## PRODUCT / PROCESS CHANGE NOTIFICATION

### PCN-000801

**Date: FEB-22-2022**

GX3290-CBE3  
GX3202-CBE3  
GX3146-CBE3  
GX3074-CBE3

New	Existing
Redstone laser marker	Rofin laser marker

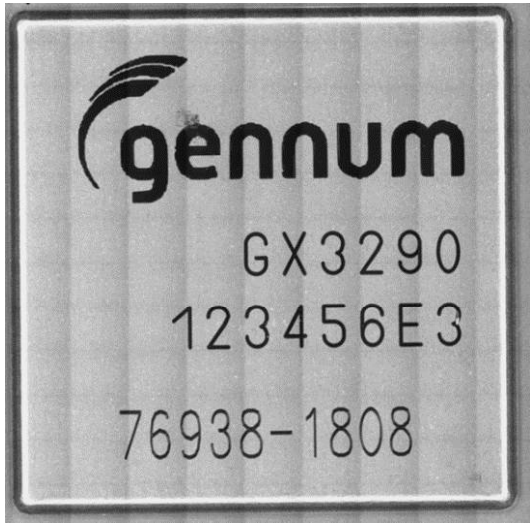
Semtech's contract manufacturer has introduced a new laser marking equipment that will replace the existing equipment as a proactive measure to ensure laser marking quality and prevent production downtime.

The marking quality of both pieces of equipment is comparable. The new marking has been inspected and tested, and it complies with all of Semtech's marking requirements and specifications.
